**Commonwealth Edison**  
One First National Plaza, Chicago, Illinois  
Address Reply to: Post Office Box 767  
Chicago, Illinois 60690

January 18, 1985

Subject: Byron Generating Station Units 1 and 2  
Technical Specifications  
NRC Docket Nos. 50-454/455

Enclosed are proposed additions and revisions to the current Byron 1 Technical Specifications. These new specifications are necessary for the issuance of the Technical Specifications which will be incorporated into the Byron full-power operating licenses. Prompt NRC review is requested. These changes were discussed with the NRC Staff at a meeting in Bethesda on January 15, 1985.

TABLE 3.6-1 (Continued)  
CONTAINMENT ISOLATION VALVES

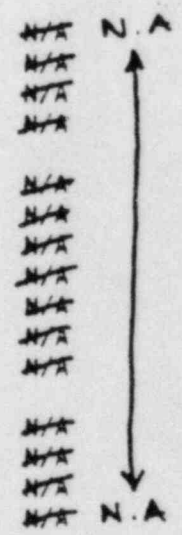
Table 3.6-1 indicates the Main Steam Isolation Bypass Valves have a maximum isolation time of 10.0 seconds. This value is inconsistent with the ESF response time for main steamline isolation of 7 seconds in Table 3.3-5 and the manufacturers design response time of less than or equal to 6.0 seconds. There had been a design problem so the bypass valves response time had been increased to 10.0 seconds and an FSAR change was made. Since then a design modification has been made so the valves now close in  $\leq 6.0$  seconds. Therefore it is requested that Table 3.6-1 be revised to reflect the 6 seconds valve closure time.

Wherever the maximum isolation time indicates "N/A" change this to "N.A." This change is requested to be consistent with the Frequency Notation listed in Table 1.1 page 1-8.
